USE OF THIS THERMOSTAT MAY REQUIRE A CHANGE TO WIRE CONNECTIONS ON CONTROL BOARD E015-71520303
LOCATED IN CONTROL BOX. EFFECTIVE DATE - 06/21/2016

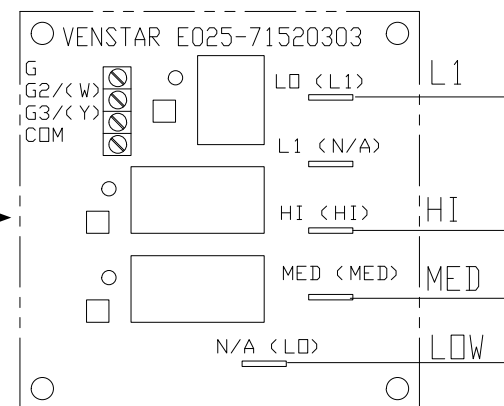
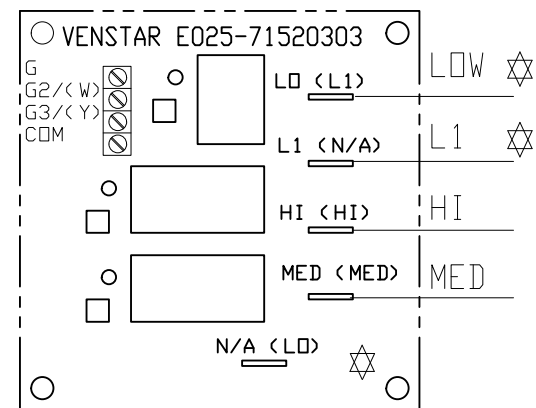
IF THE CURRENT THERMOSTAT PART#
IS ONE OF THESE NUMBERS LISTED
HERE, THE BOARD WIRING IS THIS WAY.

IF THE REPLACEMENT THERMOSTAT PART#
IS ONE OF THESE NUMBERS LISTED HERE,
CHANGE THE WIRE CONNECTIONS THIS WAY.

☆ — WIRE CONNECTIONS MOVED

NOTE: -
IF THE EXISTING THERMOSTAT IS OF THE
NEW PART #, NO WIRING CHANGES NEEDED.
